## **Central Planning Authority**

**Minutes of a meeting of the Central Planning Authority held on April 13, 2022 at 10:00am in Conference Room 1038, 1<sup>st</sup> Floor, Government Administration Building, and Elgin Avenue.**

**CPA/11/22**

*Figure 2: Original site plan overlaid onto LIS 2018 aerial imagery (Plan Source:AMR Consulting Engineers, August 2021)*

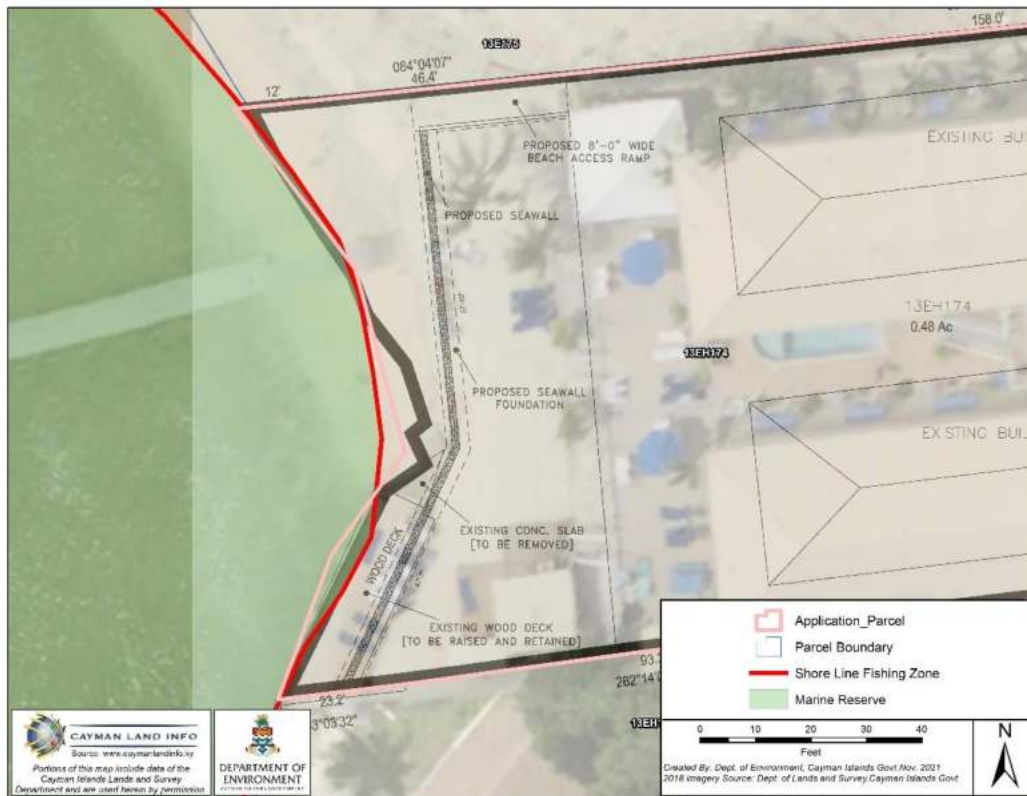
*The seawall included in the initial plans posed concerns due to its proximity to the Mean High Water Mark (MHW), as shown in Figures 2 and 3. It was located approximately 3 ft from the MHW at its closest point. The Department was concerned with potential construction impacts on the Marine Protected Area and long term impacts to the beach.*

Figure 5: Showing revised plans overlaid onto LIS 2018 aerial imagery (Plan Source: AMR October 2021)

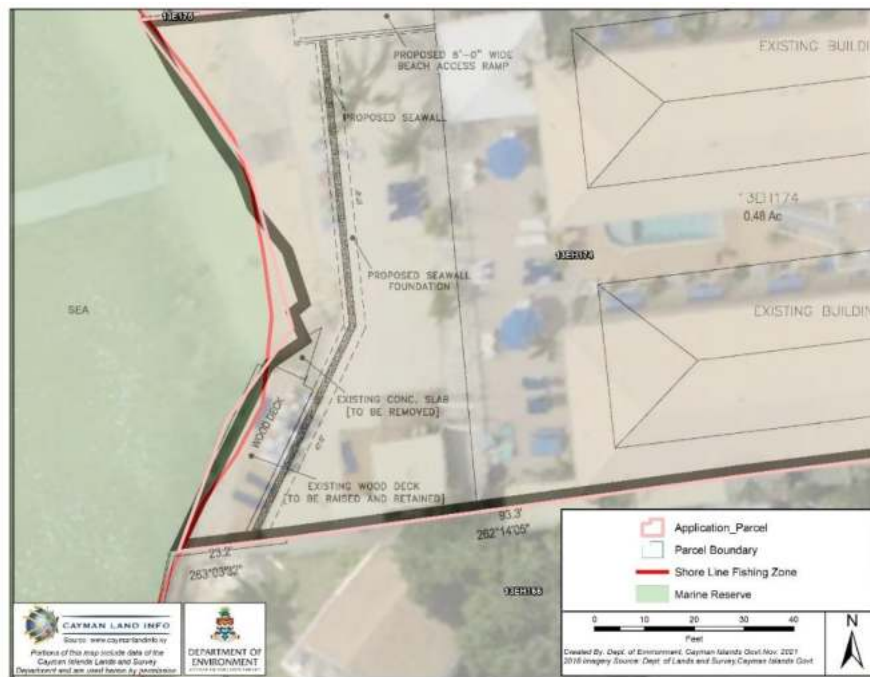
Once in receipt of the revised plans, they were overlaid onto LIS 2018 aerial imagery (see Figures 5 and 6), which confirmed that the wall has been moved 4ft back.

Figure 6: LIS 2018 aerial imagery showing the revised seawall location in relation to the originally proposed location

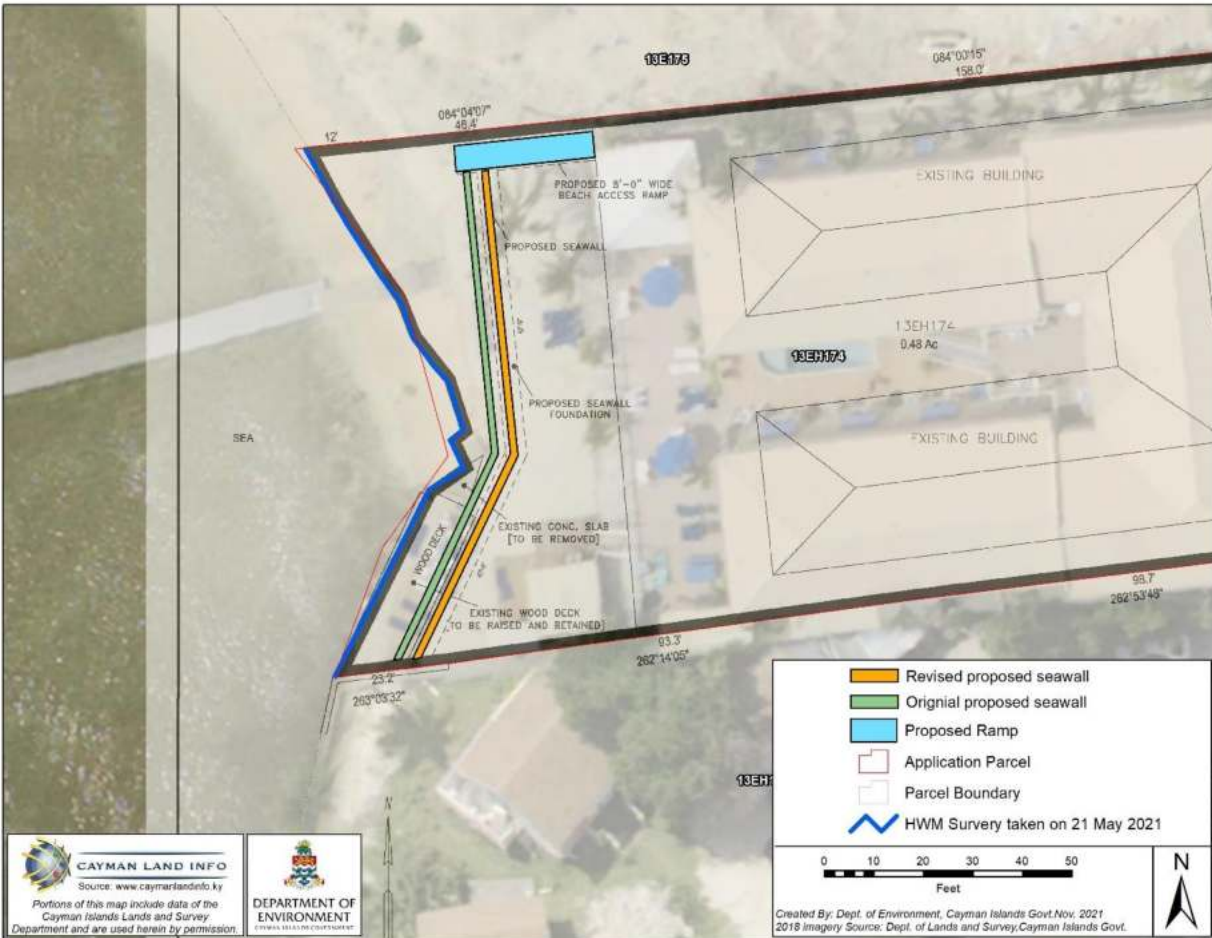
It is strongly recommended that the applicant pulls the wall back as far as possible. The proposed mitigation measures that the contractor has proposed should assist with mitigating some of the impacts to the Marine Protected Area.

Figure 7: Showing wave energy distribution (source the CT Mirror 2013- Connecticut's trouble with seawalls)

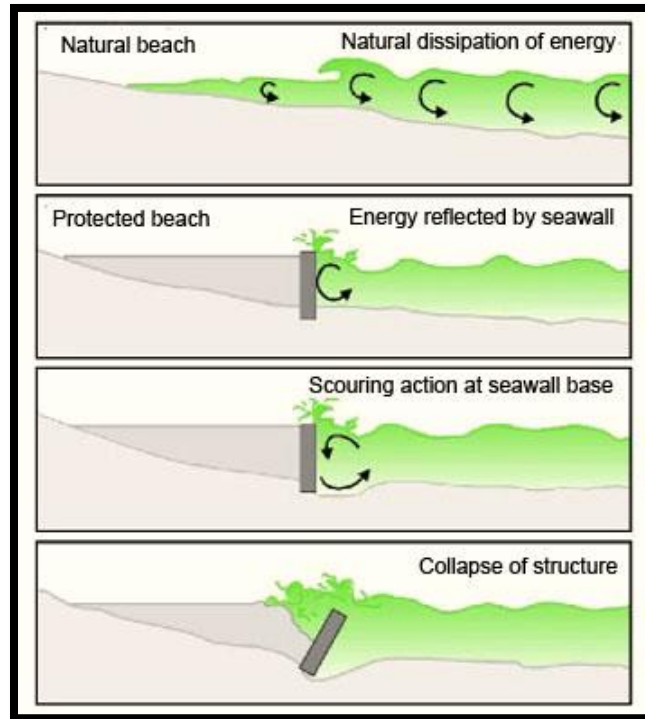
The presence of a seawall interacting with waves on a beach is a well-documented cause

**Figure 1: LIS 2018 aerial imagery showing application site outlined in red.**

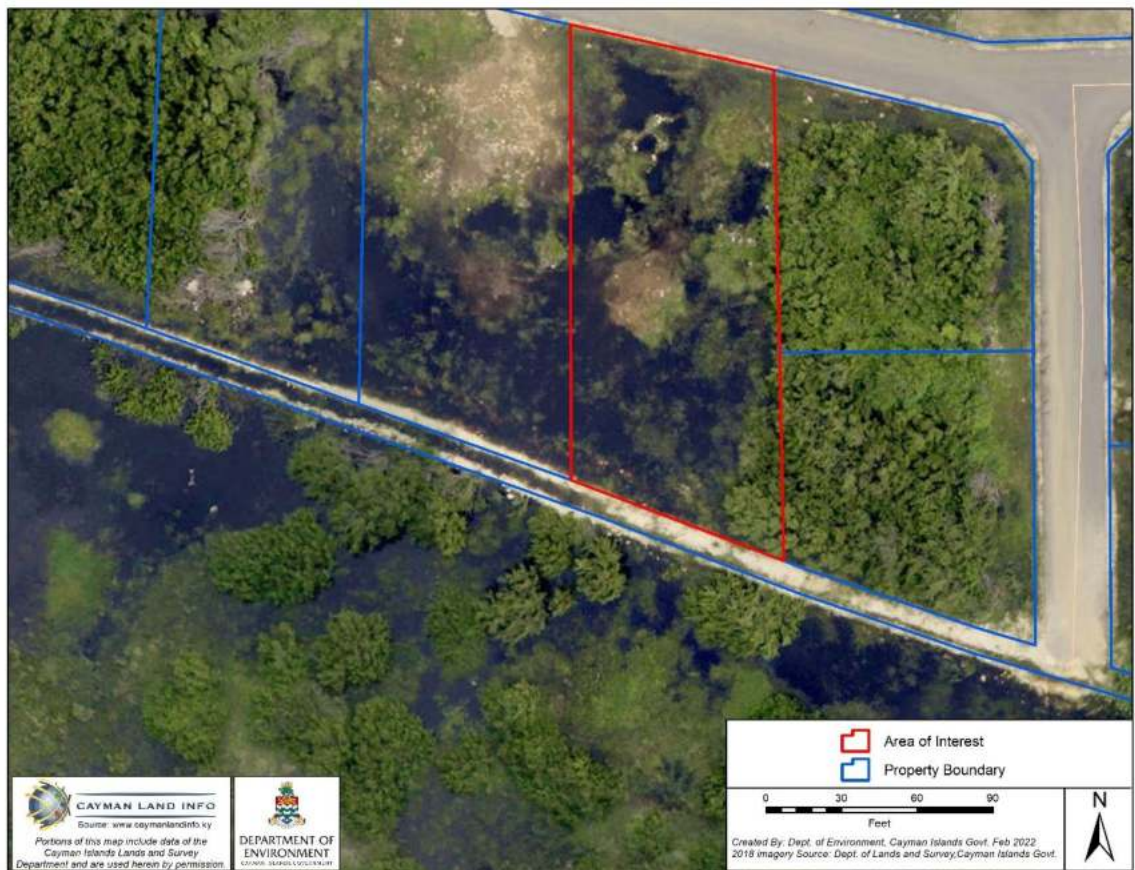
*The application site is low-lying, given the area is a converted wetland habitat. Based on the 2018 aerial imagery, the application site at that time consisted of a mixture of man-modified areas, a regrowth of wetland vegetation and water as shown in Figure 1. It is noted that the application site forms a part of a wider subdivision that was approved on 17 December 2014 (Meeting CPA/31/14; Item 2.4. Planning ref: P14-0779/F14-0172). Condition 2(b) of this approval required the lots to be filled to 4 feet above mean sea level.*

*Nonetheless, it is the DoE's preference for applicants to submit proposals for land clearing and filling along with their proposals for development as there may be varying recommendations for vegetation retention depending on the form and nature of the development being proposed. For example, we often recommend the retention of any wetland vegetation located outside of the development footprint to assist with on-site drainage.*

*The DoE also recommends that land clearing and filling not take place until the construction of the approved development is imminent to allow for the site to continue to provide ecological services such as a habitat for native fauna and migratory bird life and serving as a natural catchment basin and contributing to the stormwater drainage capacity of the wider wetland area.*
